**SUBJECT: Structure Type Study Resubmission
Shumway Hollow Road over CSXT Railroad
SCI-823-0.00 Portsmouth Bypass
PID#19415**

SCI-823-0.00

SHUMWAY HOLLOW ROAD OVER CSXT RAILROAD

STRUCTURE TYPE STUDY SUBMITTAL

PLAN

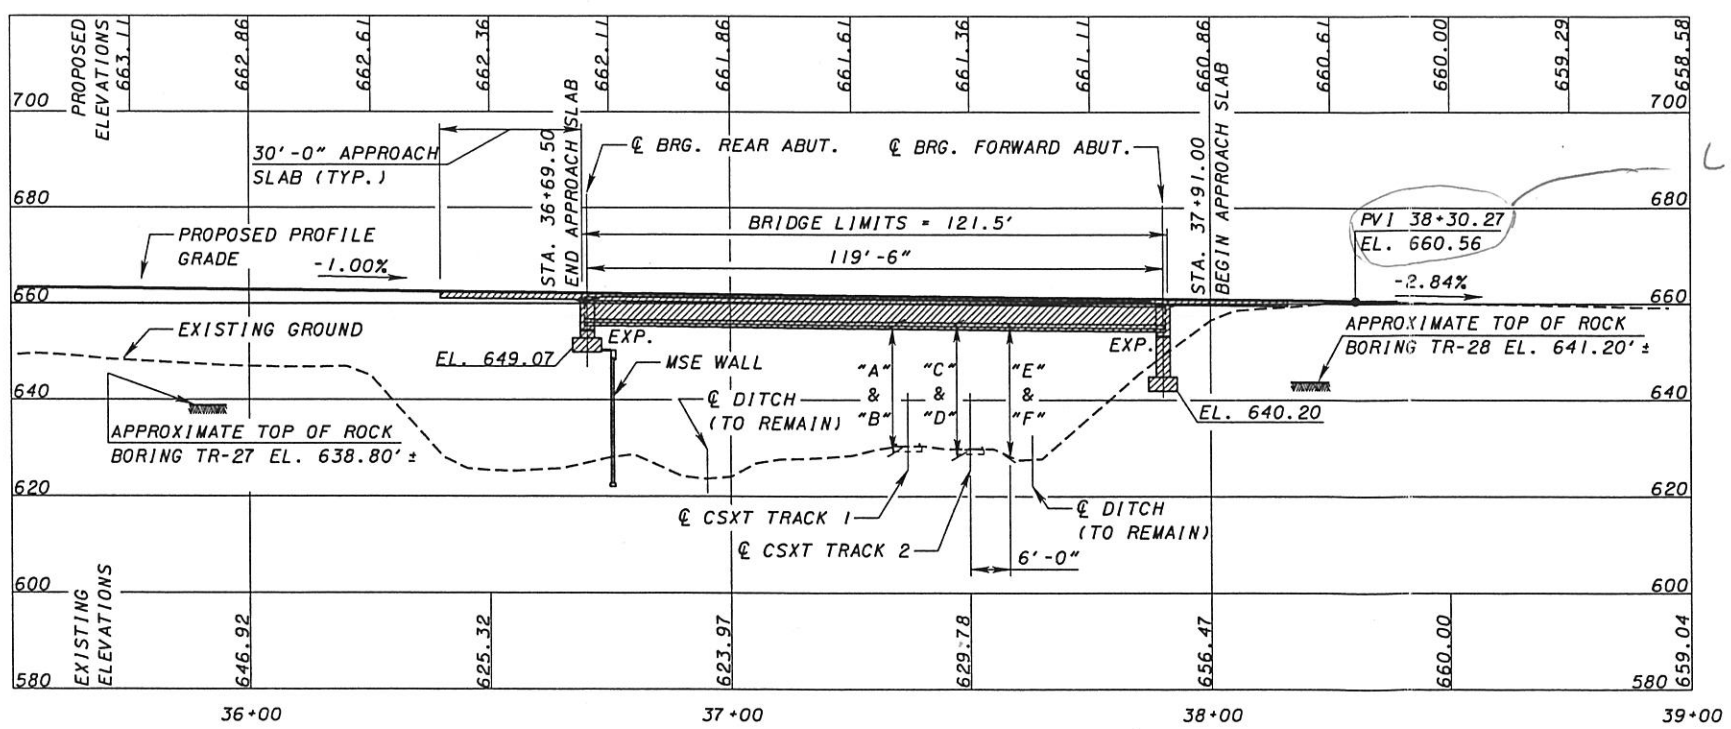
no semi-integral

*Length of curve
horizontal curve
14%*

TYPICAL TRANSVERSE SECTION

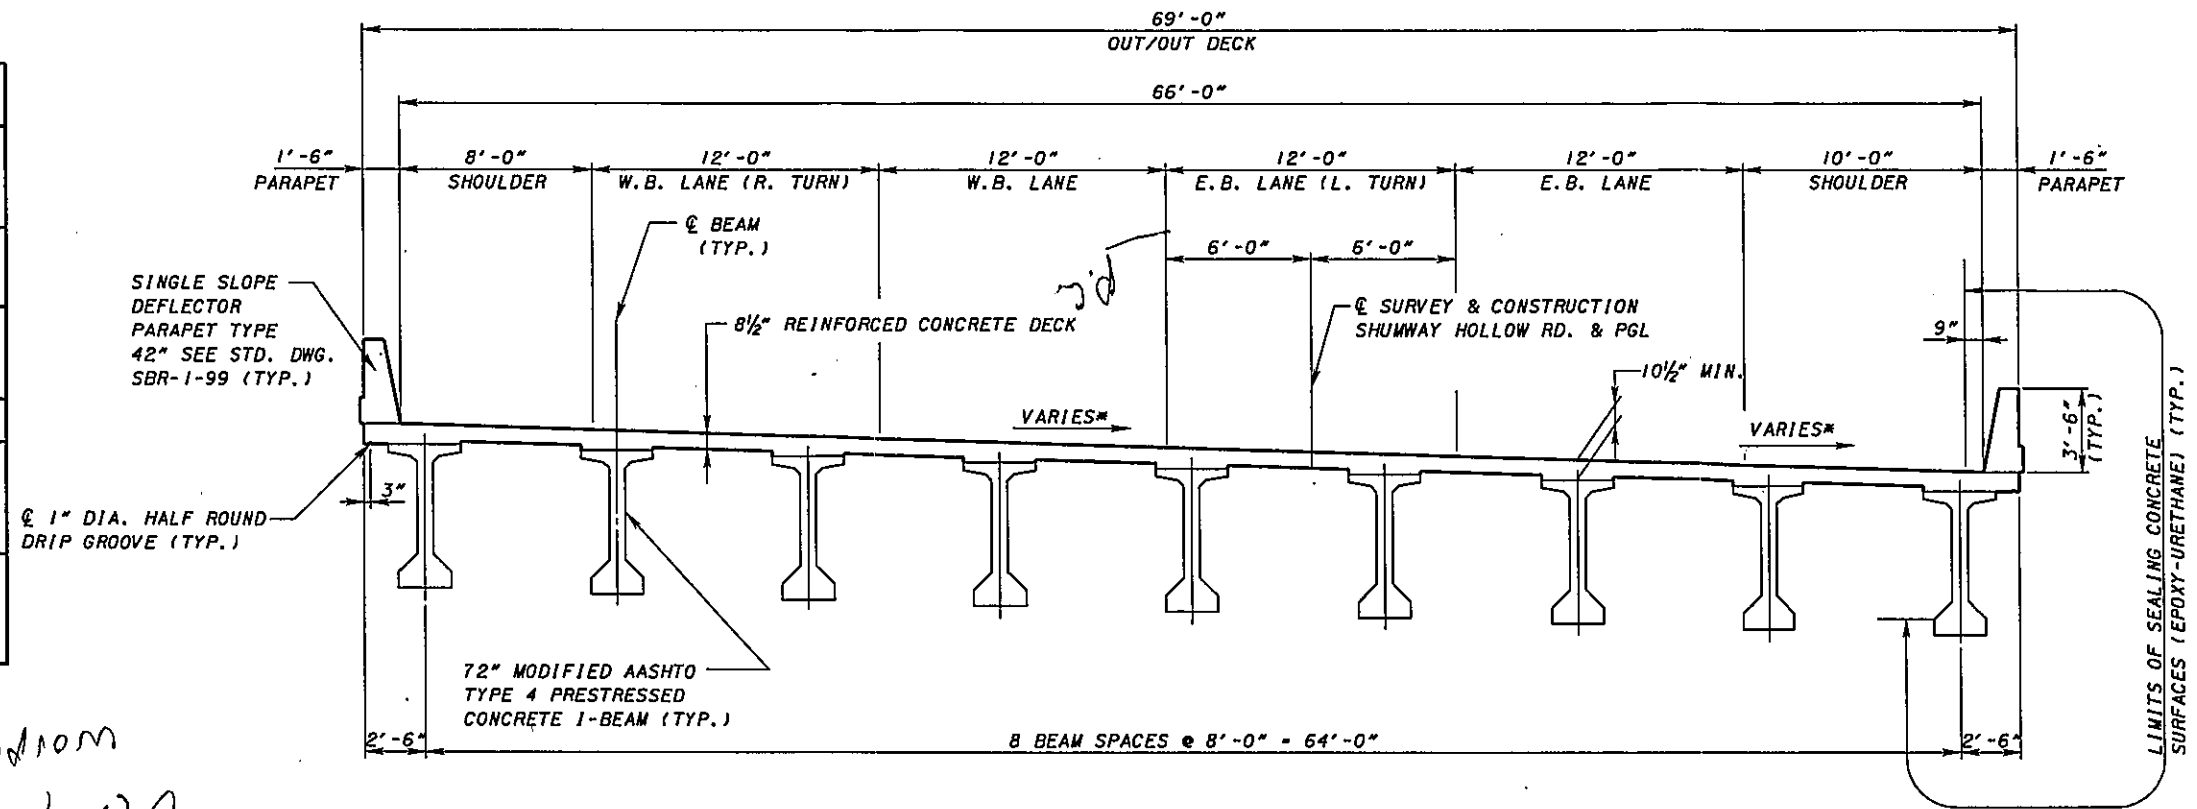
*Verify deck thickness
warping of deck*
